# County of Fairfax, Virginia

Re: Interpretation for RZ 82-P-044; Tax Map 49-4 ((1)) 59;  
7700 Arlington Boulevard: Site Modifications

Re: Request for Approval of Minor Modifications  
RZ 82-P-044 concurrent with SE 82-P-048  
Fairfax County Tax Map Reference: 49-4 ((1)) 59 (the "Subject Property")  
Applicant: GBA Associates

**EXHIBIT**  
**11**  
 sheets

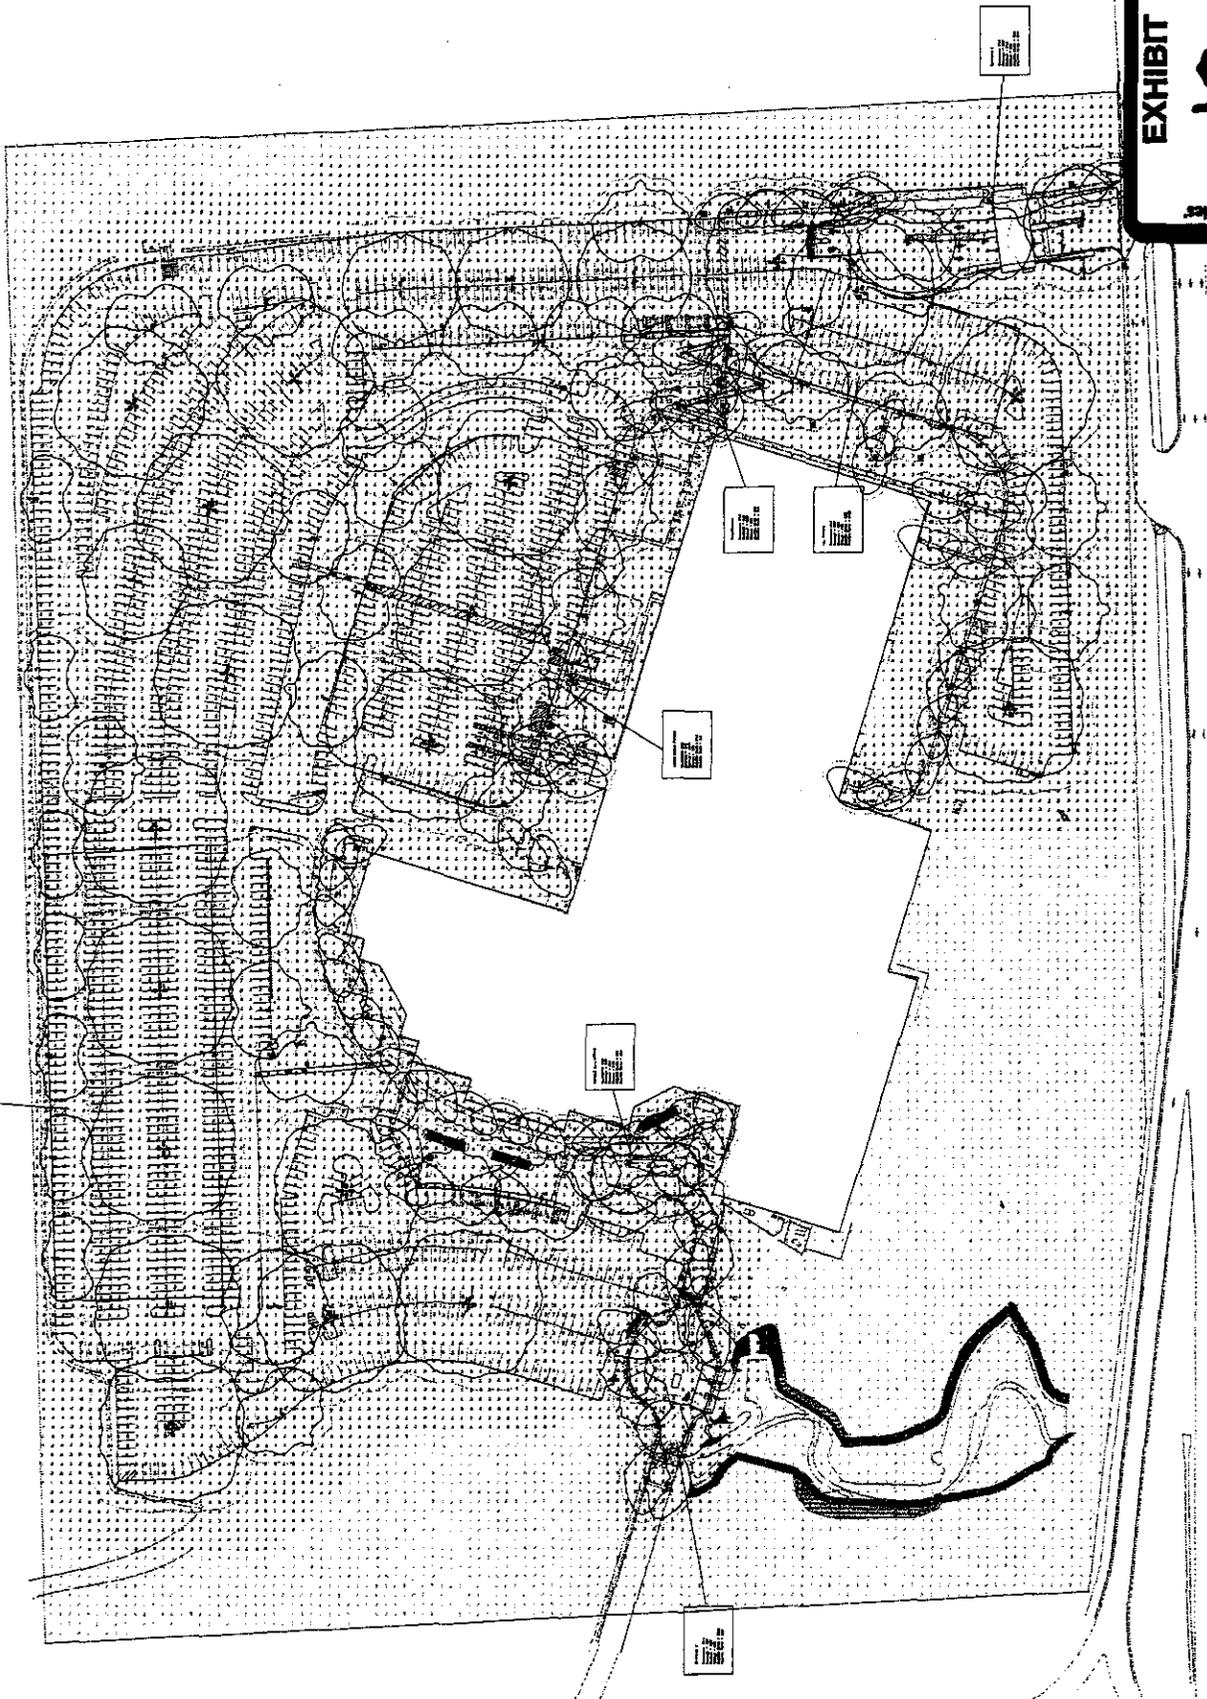
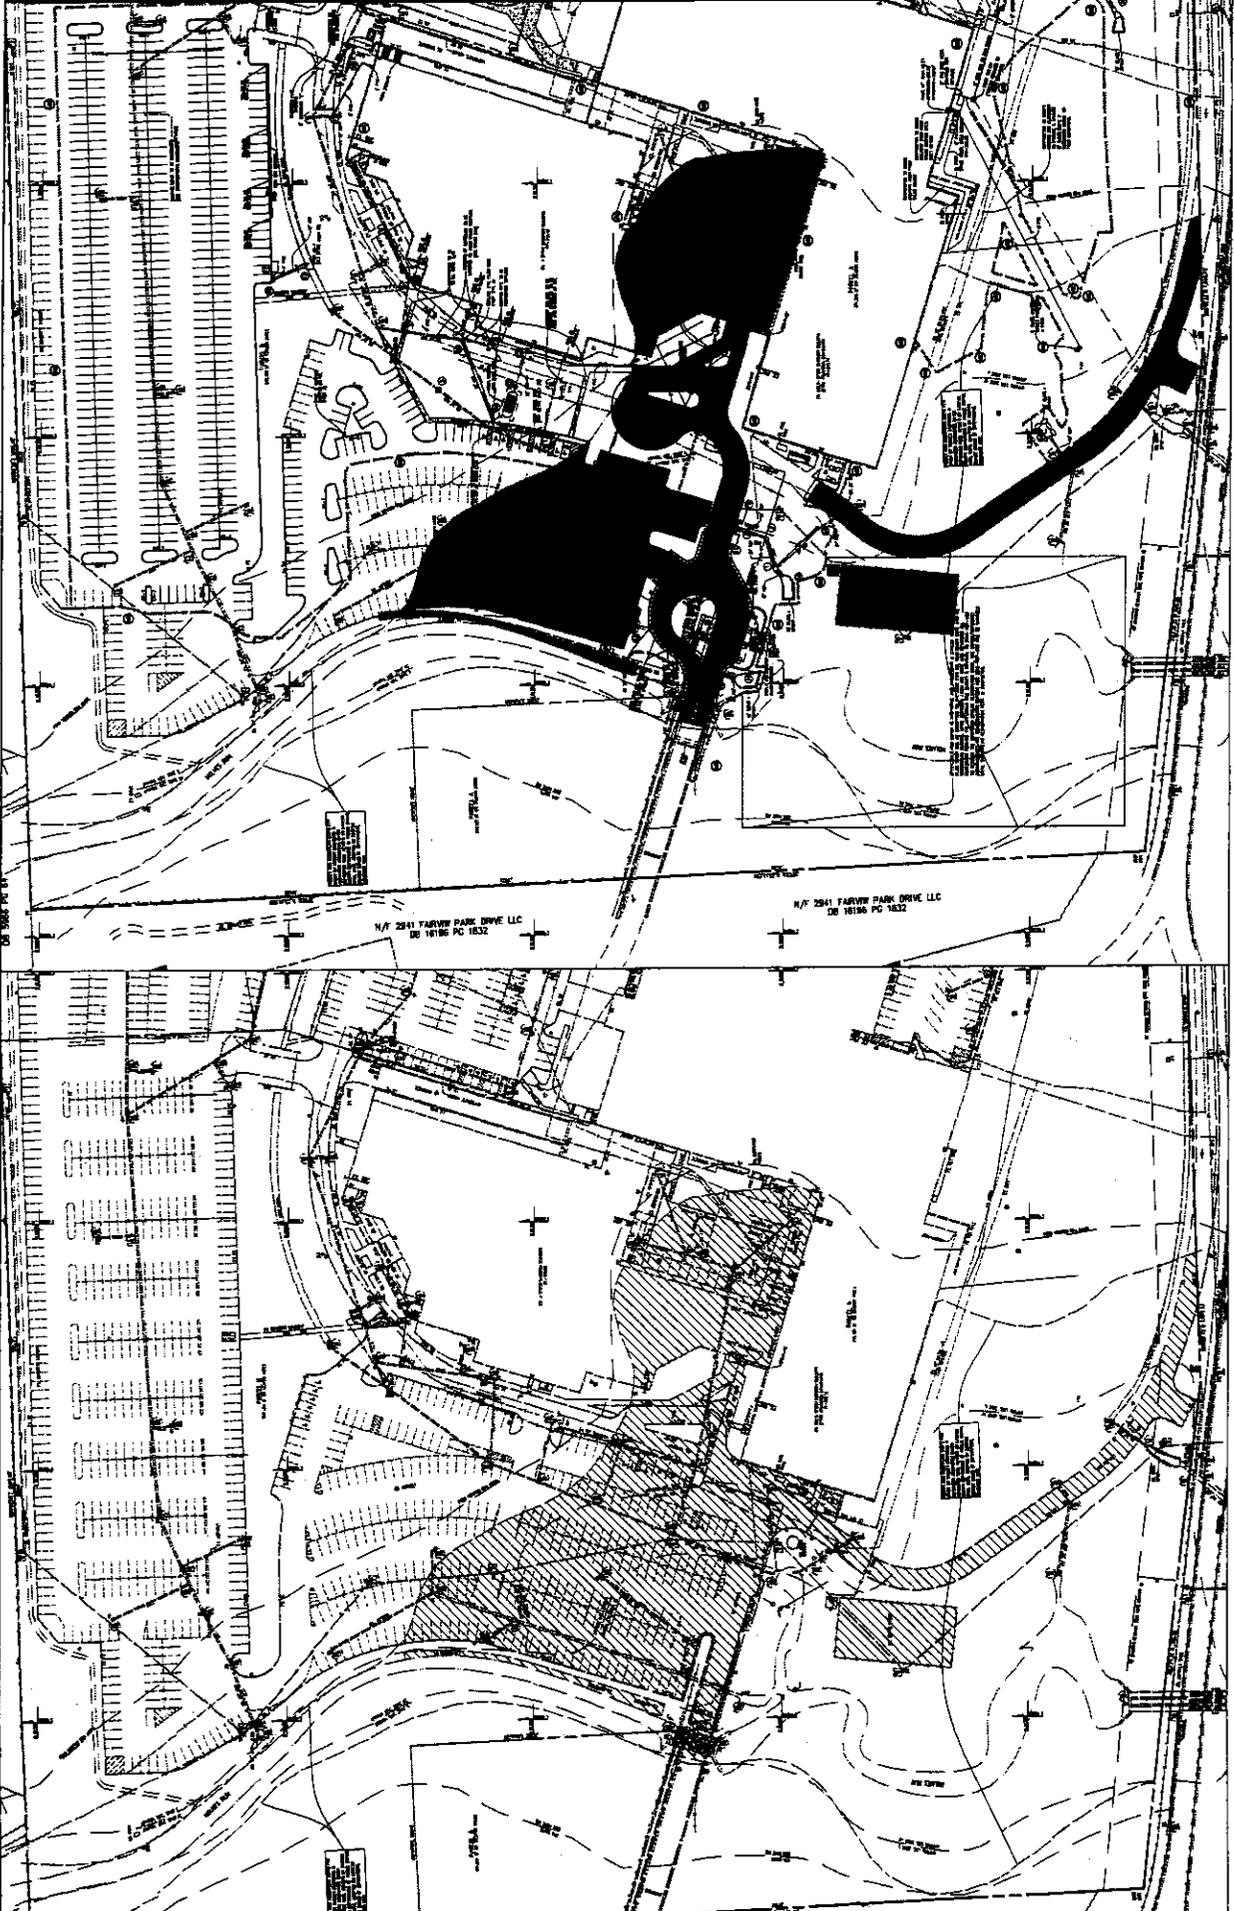
**Improvements in the Floodplain.** The existing improvements in the floodplain are governed by SE 82-P-048, which was approved concurrently with the rezoning. The subject area includes the access near the west entrance to Fairview Park Drive. Your letter states the applicant is not filling in the floodplain with the current minor site plan, and that while a guard house is installed in the floodplain as depicted on Exhibit 4, there is no additional impervious surface created. You state that the location of the guard house was deemed to be redevelopment during the minor site plan review process. According to Exhibit 11 (titled "Floodplain Impervious Area Exhibit," dated April 2, 2012), the amount of impervious surface within the floodplain is decreased with the proposed site layout by 17,108 square feet. You also state that since the adoption of the Chesapeake Bay Preservation Ordinance, a portion of the property is designated as Resource Protection Area (RPA). According to Exhibit 12 ("RPA impervious Area Exhibit," dated April 4, 2012), the impervious area within the RPA is decreased with the proposed site layout by 29,015.28 square feet.

The existing improvements located in the floodplain were previously permitted in accordance with SE 82-P-048. The approved special exception refers to the GDP and includes the access referred to as Fairview Park Place. The Applicant is not filling in the floodplain with the proposed minor site plan. While a guard house is being installed in the floodplain as shown on Exhibit 4, there is no additional impervious surface created. For this reason, the location of the guard house within the floodplain was deemed to be redevelopment during the minor site plan review process. As shown in an enclosed exhibit entitled "Floodplain Impervious Area Exhibit" prepared by Urban Engineering and dated April 2, 2012 (Exhibit 11), the amount of impervious surface located within the floodplain is decreased with the proposed site layout by 17,108.76 square feet.

It is my determination that the location of a guard house within the floodplain would be in substantial conformance with the proffers, GDP, SE Plat and development conditions, subject to final approval by DPWES.

**EXHIBIT**  
**12**

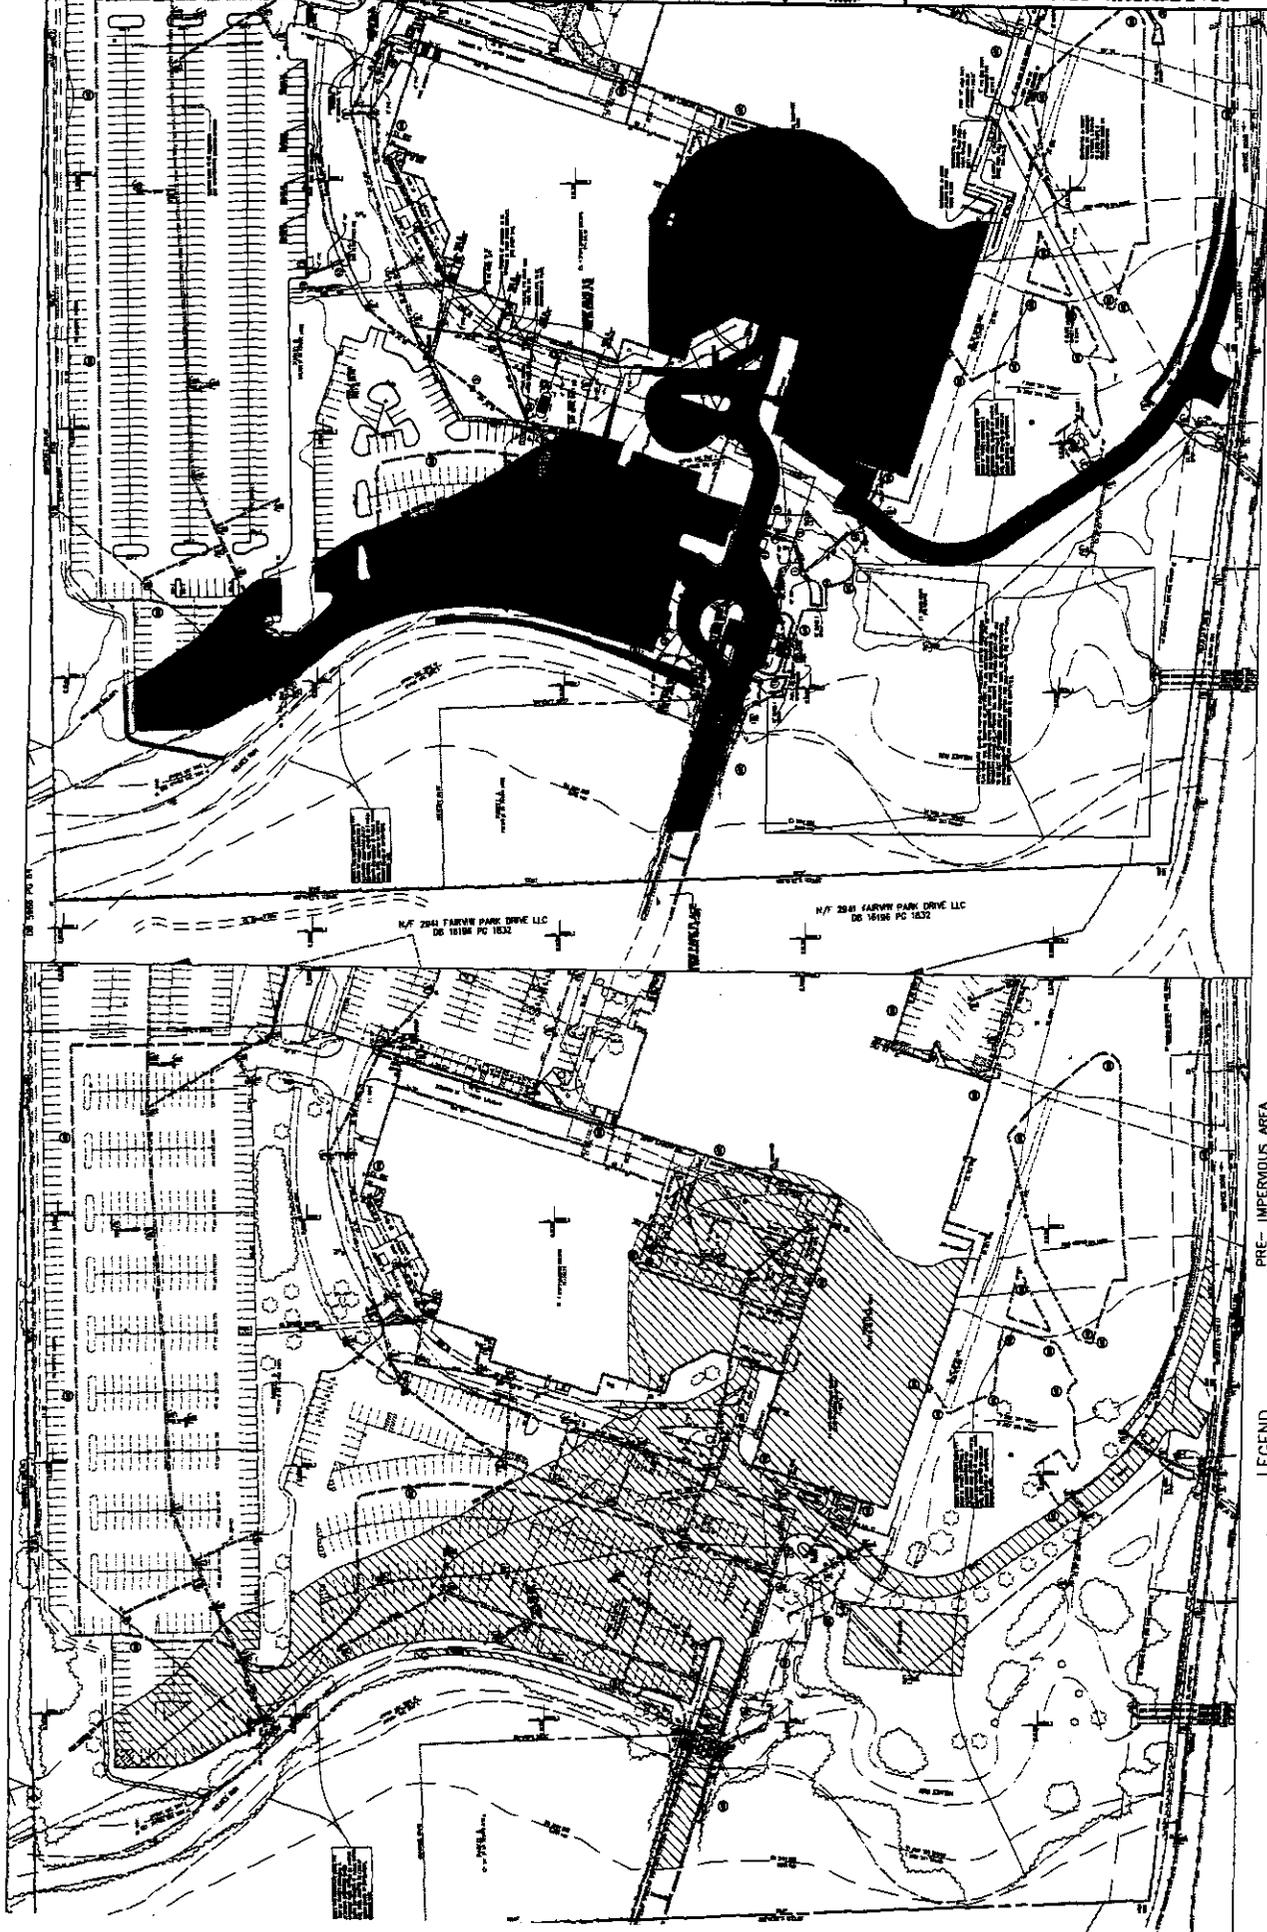
Since the adoption of the Chesapeake Bay Preservation Ordinance, a portion of the Subject Property is designated as Resource Protection Area (RPA). As shown in an enclosed exhibit entitled "RPA Impervious Area Exhibit" prepared by Urban Engineering dated April 4, 2012 (Exhibit 12), the impervious area within the RPA is decreased with the proposed site layout by 29,015.28 square feet.
